UNITED STATES
NUCLEAR REGULATORY COMMISSION
WASHINGTON, D. C. 20555

Docket Nos. 50-549
50-596
and 50-597

Evaluation of Prof. Gulbransen's Letter on Zirconium Hydride in TMI-2

MEMORANDUM FOR: Paul S. Check, Chief, Reactor Safety Branch, DOR
THRU: Carl H. Berlinger, Section Leader, Reactor Safety Branch, DOR
FROM: Kris I. Parczewski, Reactor Safety Branch, DOR
SUBJECT: FORMATION OF ZIRCONIUM HYDRIDES IN THE THREE MILE ISLAND-2
INCIDENT

Figure 2—Operating Limits for Steels in Hydrogen Service Showing Effect of Trace Alloying Elements

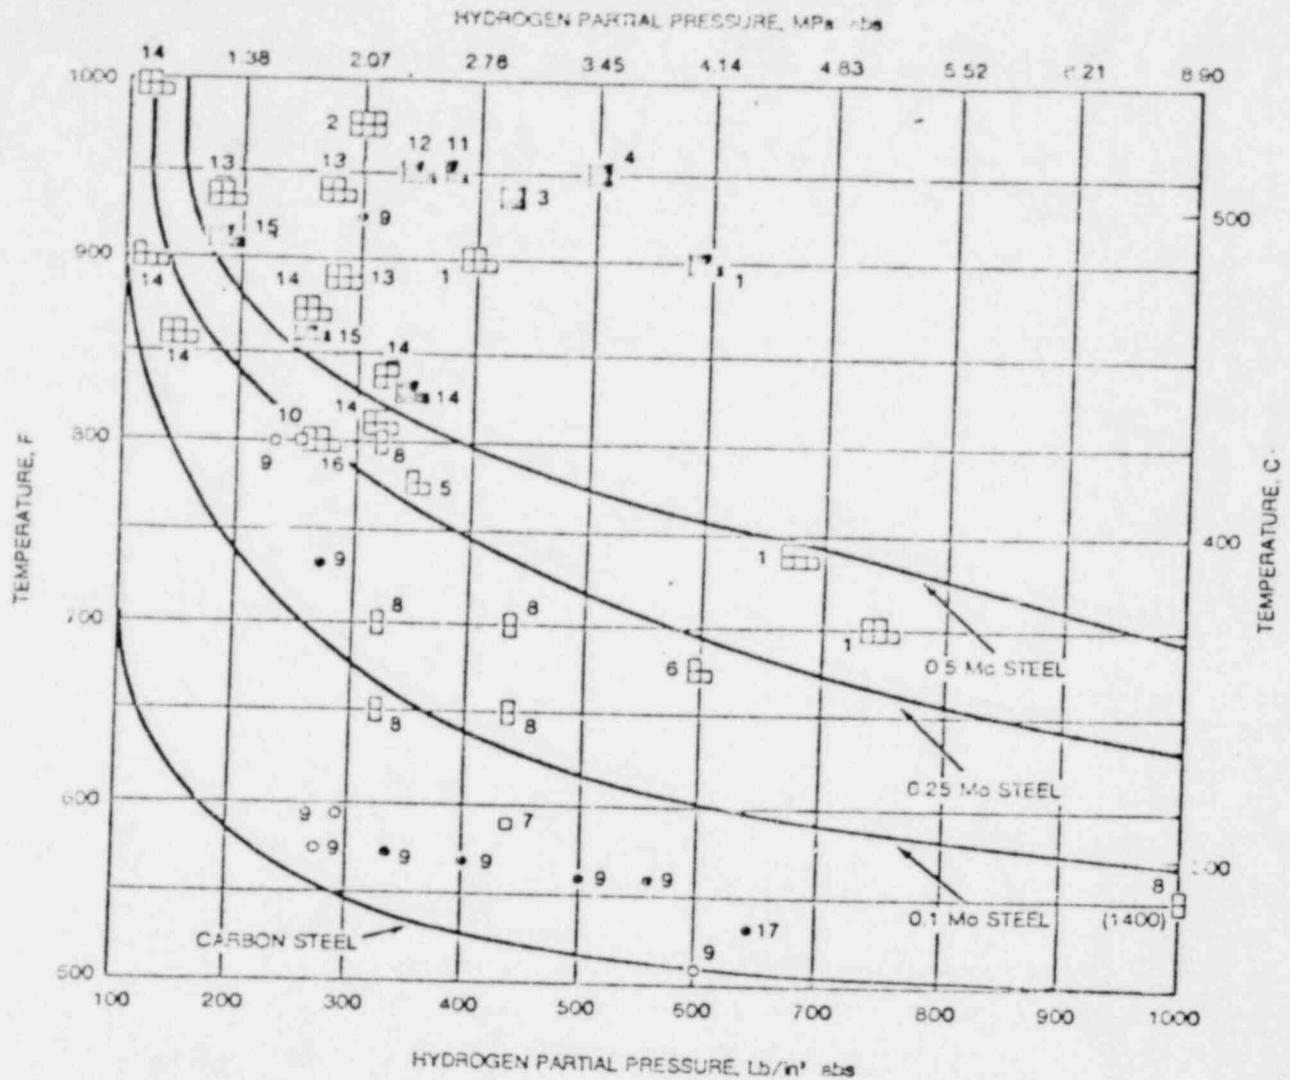
Warren Hazelton asked me what information I had on the thermodynamics and kinetics of the reaction of hydrogen at a high temperature and pressure inside the reactor vessel on the possible decarburization of and methane formation in the vessel material. I discussed this subject with David Gurinsky and J. Chow of BNL, M. Gensamer, Professor Emeritus at Columbia and A. Ciuffreda of Exxon Research. The stainless steel cladding on the inner surface of the vessel would be a partial barrier to hydrogen provided it were intact. There is enough of a chance of a flaw in this cladding, however, that no credit should be taken for it in estimating the performance of the reactor vessel material. The reactor vessel is made of a pressure vessel steel (ASTM A-533-B) which contains 1% Mn, 0.5% Ni and approximately 0.5% Mo. The oil industry is continuously concerned about hydrogen induced decarburization of steels in their refinery equipment. They have prepared a graph stating the safe temperature and pressure for steels (Nelson Diagram) in the American Petroleum Institute report API-941, which was most recently modified in 1977. A steel of the composition used in the Three Mile Island vessel should be safe from decarburization by 1000 psi of hydrogen at temperatures up to 700°F for indefinite use. Exceeding this temperature or pressure for short periods would not cause serious damage as there is a definite incubation time, of a matter of several days, before problems begin to develop. Mo appears to be even more effective than Cr in retarding this decarburization although the reasons are not clear. The same steel without the Mo would only be safe up to 500°F at 1000 psi of hydrogen. I think the upper part of the reactor vessel should be carefully checked for any possible damage from decarburization prior to its return to service. A copy of the curve showing this relationship as revised in 1977 is appended to this memorandum.
